Access Compliance Report

Public Rights-of-Way

(Curb Ramps)

Intersection ID: 10654	Main Street: E_35TH_ST	Cross Street: WESLEY_AV	Location: W
ADA ID: F92CF492E3A6	Ramp Type: PerpDiag	Initial Pass/Fail: Fail	Overall Compliance: No
			Severity Score: 13.75

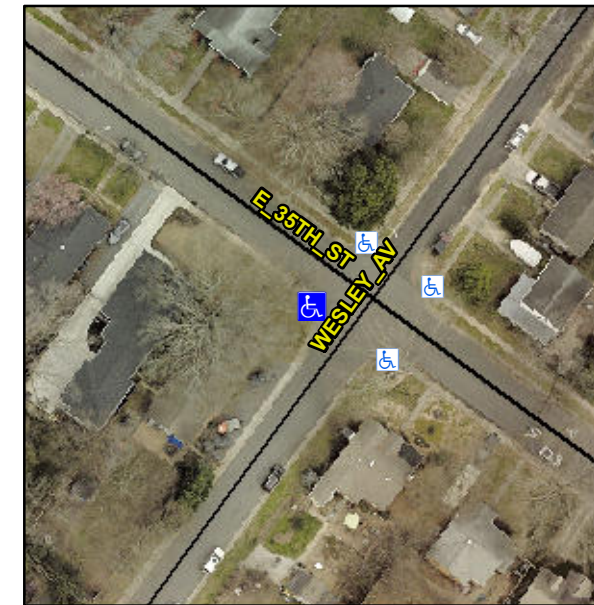
Not Found, R304.2.2, R304.5.3

Compliance	Description	Data	Compliance	Description	Data
N/A	Ramp Length (in)	51.0	No	Ramp Slope (%)	11.1
Yes	Ramp Width (in)	52.0	No	Ramp XSlope (%)	3.0
N/A	Flare Type LT	N/A	N/A	Flare Type RT	N/A
N/A	Flare Slope LT (%)	N/A	N/A	Flare Slope RT (%)	N/A
N/A	Flare Traversable LT?	N/A	N/A	Flare Traversable RT?	N/A
N/A	Landing Length (in)	N/A	N/A	DWS Provided?	N/A
N/A	Landing Width (in)	N/A	N/A	DWS Contrast?	N/A
N/A	Landing Slope (%)	N/A	N/A	DWS Length (in)	N/A
N/A	Landing X Slope (%)	N/A	N/A	DWS Full Width?	N/A
N/A	Landing Curb? (Y/N)	N/A	N/A	DWS Offset (in)	N/A
N/A	Shared Landing?	N/A			
N/A	Gutter Ponding?	N/A	N/A	Gutter Slope (%)	N/A
N/A	Gutter Lip Ht (in)	2.0	N/A	Gutter X Slope (%)	N/A
N/A	Painted X Walk1?	No	N/A	Painted X Walk2?	No
	X Walk 1 Direction	To SE		X Walk 2 Direction	To NE
N/A	X Walk 1 Width (in)	N/A	N/A	X Walk 2 Width (in)	N/A
	X Walk 1 Slope (%)	2.7		X Walk 2 Slope (%)	2.2
	X Walk 1 X Slope (%)	0.9		X Walk 2 X Slope (%)	1.8

Remove & Replace Curb Ramp With Two New Directional Ramps or Equivalent.
